STAFF RECOMMENDATION

NCPC File No. 6479

SMITHSONIAN INSTITUTION
PATENT OFFICE BUILDING
PERIMETER SECURITY, LANDSCAPE PLAN, F STREET STAIR RECONSTRUCTION, AND
TEMPORARY EGRESS STAIR
G, F, 7th and 9th Streets, NW
Washington, D.C.

March 29, 2007

Elevation and section showing the proposed reconstruction of the monumental stair on F Street, NW.

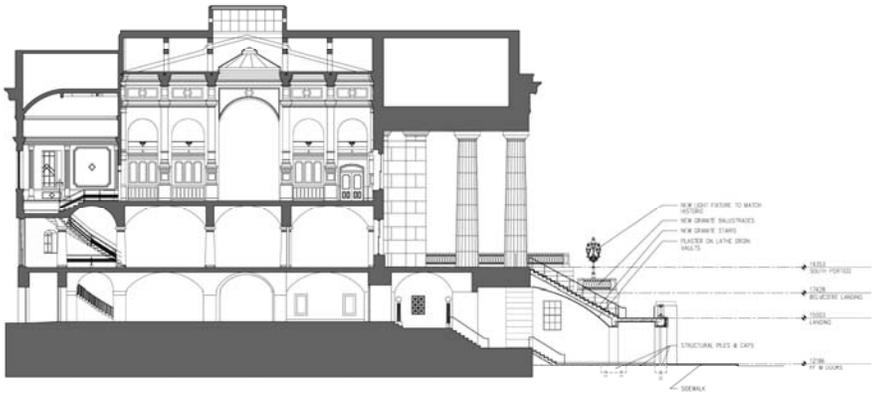
The reconstruction, unlike the original, will have three doors at the sidewalk for an accessible, at-grade entrance. Staff recommends that the Smithsonian’s preferred option of using gates at the entrance openings, with glass doors set behind, be selected.

Proposed plan for perimeter vehicle barrier

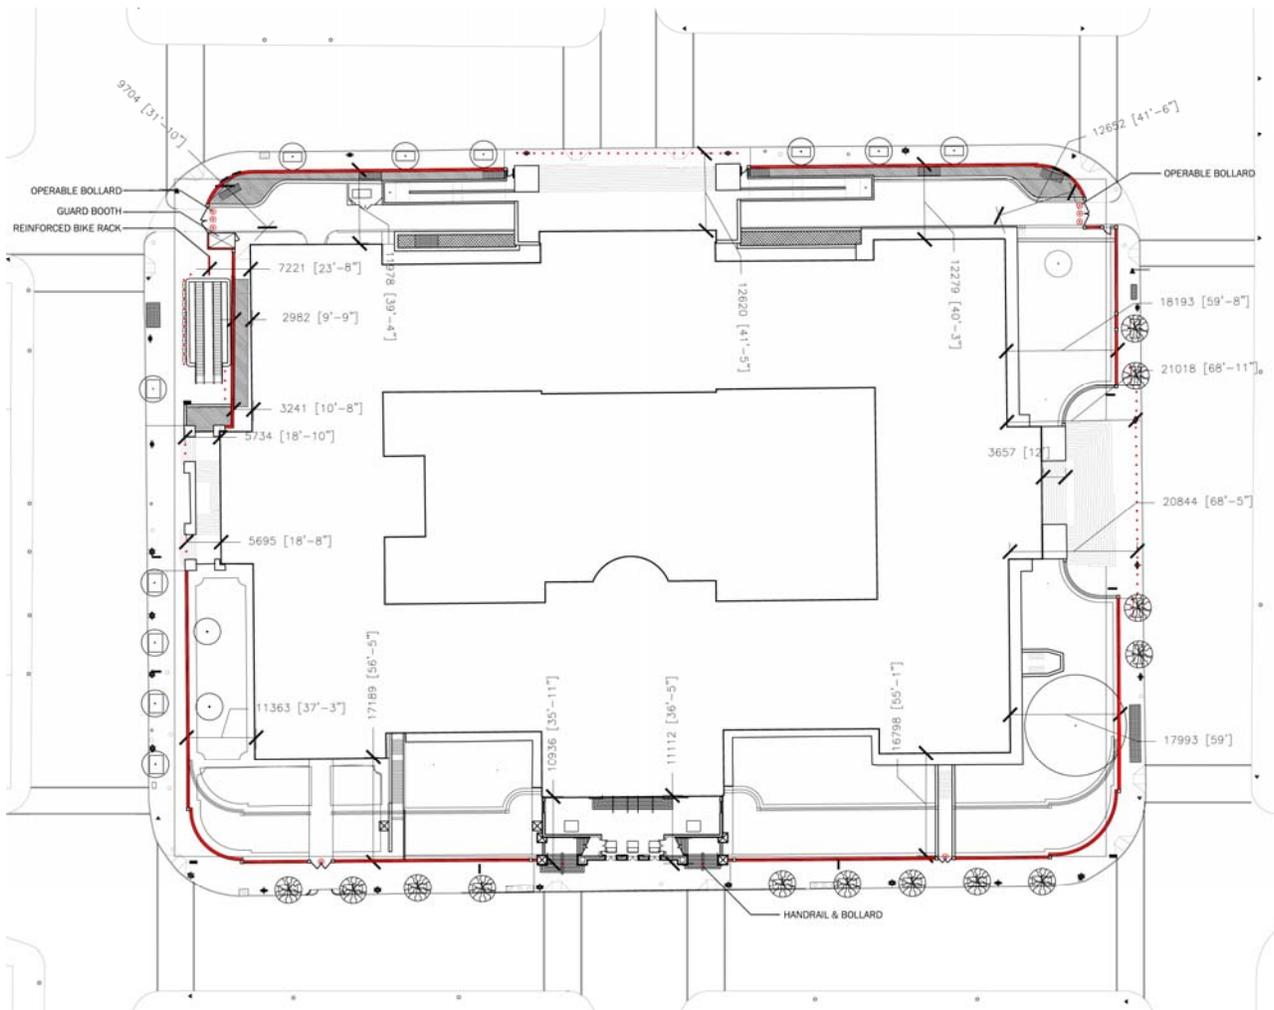
The staff accepts the Smithsonian's revised concept for the design of a perimeter barrier, if determined to be necessary, to be located at the edge of the lawn, inside the sidewalk around most of the reservation, keeping the barrier out of the pedestrian realm as much as possible. The Smithsonian staff and their design team have responded to design and historic preservation comments of the staff and other review agency staffs and public consulting parties to date.

The staff recommends, however, that the Commission request that the Smithsonian reassess whether perimeter security is warranted around the Patent Office Building prior to submission of preliminary site and building plans for the landscape and F Street stair.

Section of proposed retaining wall (on the F Street and 7th Street sides of the reservation).

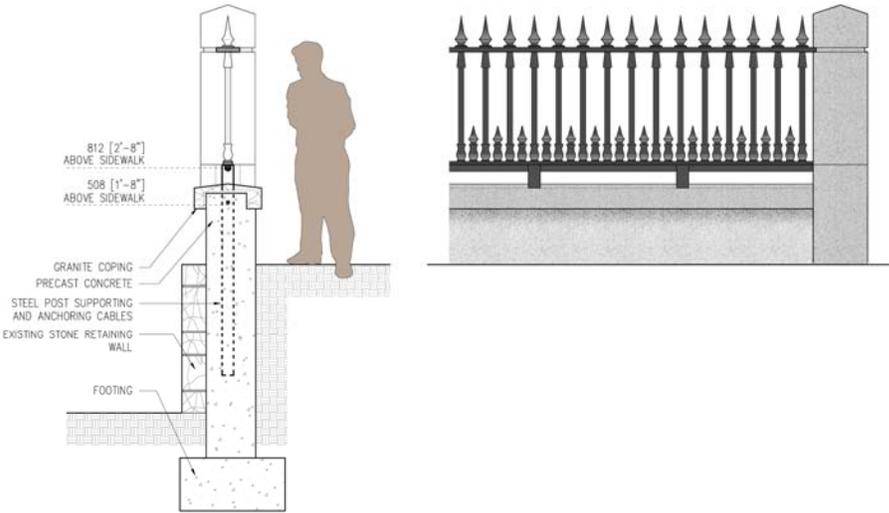
Given the perimeter barrier options available and studied, staff recommends that the Commission comment that the proposed alteration of the granite wall to create retaining and free-standing walls approximately 26 inches high, and the hardening of the cast iron fence by the installation of a cable and posts at its lower edge, is an acceptable and a viable design solution, but also request that the Smithsonian Institution reassess whether perimeter security is warranted around the Patent Office Building prior to submission of preliminary site and building plans for the landscape and F Street stair.

Proposed bollard line with existing sidewalk and curb (5'10" pedestrian clearance).

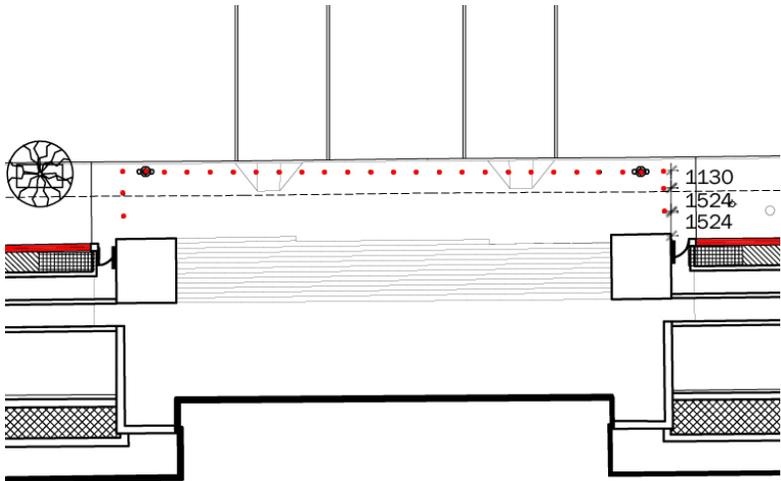
At the G Street entrance, the sidewalk would be narrowed to 1725 millimeters or less than 6 feet. This clearance is undesirable at the entrance to the museum. The sidewalk, at least at the entrance, should be widened for the benefit of museum visitors as well as pedestrians in this increasingly busy part of downtown with high pedestrian traffic. Smithsonian and review agency staffs have met with DDOT representatives several times and will continue to take steps to ensure that the possibility of widening the sidewalk is studied fully and implemented if possible. Funding is a significant hurdle. The Smithsonian should provide information as it develops before the preliminary stage of review.

Staff recommends that the Commission not comment favorably on a bollard line at the current G Street curb because it would narrow the sidewalk in front of a major museum entrance to approximately 6 feet. Instead, the sidewalk entrance should be widened for the benefit of museum visitors as well as pedestrians in this increasingly busy part of downtown with high pedestrian traffic. Staff recommends that the Smithsonian and other agencies continue to meet with DDOT to study widening the sidewalk by narrowing the cartway of G Street, at least in front of the stairs.

Since parking spaces are desired along the south side of G Street, staff recommends that at a minimum the sidewalk in front of the stairs (facing 8th Street, on axis) be widened to include the parking lane, since no vehicles should be allowed to park in front of the Patent Office to block the view of the entrance on the 8th Street axis in any event. It is now marked as a no-parking zone. Vehicle drop-off zones could be created on one or both sides of the G Street stair entrance, near the handicap ramps.

Smithsonian rendering of proposed bollards interspersed with (existing) newspaper boxes at Gallery Place Metro station escalator wall.

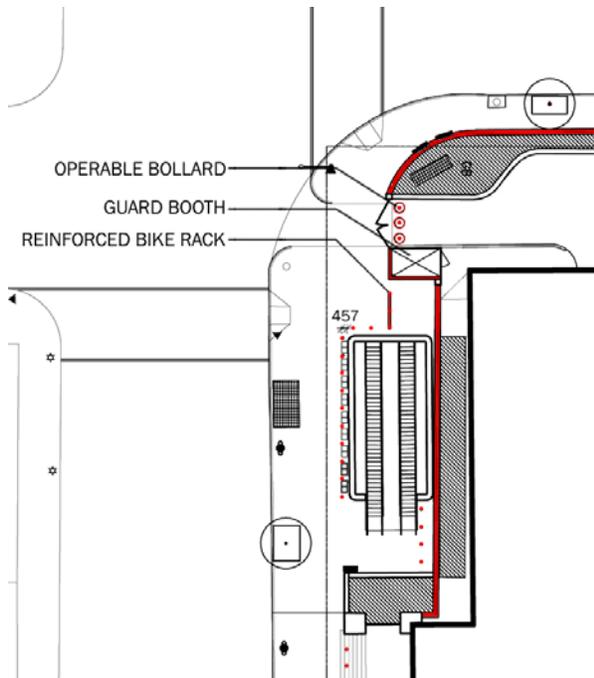
Staff recommends that the Commission not comment favorably on the proposed bollard line in front of the Metro escalator wall and the building's moat wall, and recommends instead continued study of other means of providing an acceptable barrier and standoff distance, including reinforced or hardened street furniture such as newspaper boxes.

Recommends that the Smithsonian develop a barrier around the Metro escalator, if determined to be necessary, that uses hardened street furniture (including perhaps hardened newspaper boxes) to avoid the use of bollards.

Temporary egress stair from portico on F Street façade

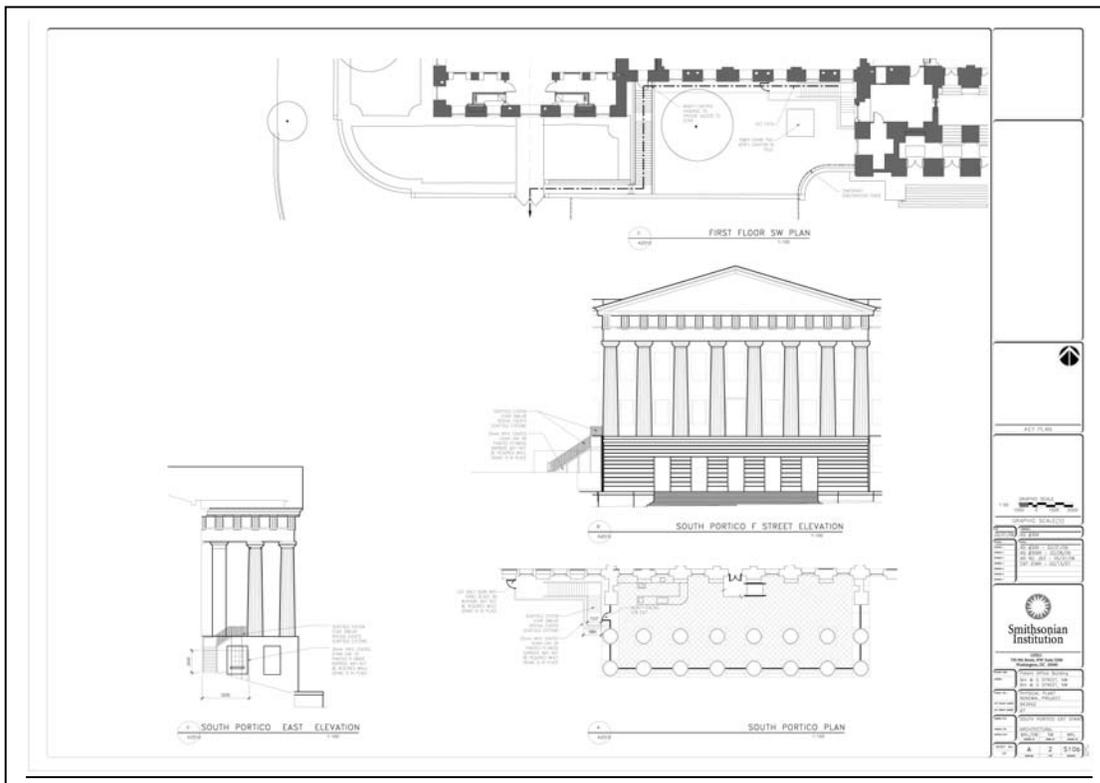
The staff is pleased that the museum is operating a popular outdoor café on the portico and endorses the Smithsonian's proposed experiment to expand its capacity this summer. The use of a temporary, demountable metal egress stair is seasonal and requires no permanent change to the building. The Smithsonian can submit a proposal to the Commission next year for another period of temporary installation if it wishes to continue the arrangement. Given the presence of the construction fence in front of the building this season, which will block the view of the metal stair from street level views, and the experimental nature of the proposal, the staff recommends that the Commission endorse the concept as supportive of the building's and the future F Street stair's use as a public amenity in Downtown.

The staff recommends that the Commission approve the concept design for the installation of a temporary egress stair for the Portico Café for the 2007 warm-weather season only and delegate the final approval to the Executive Director.
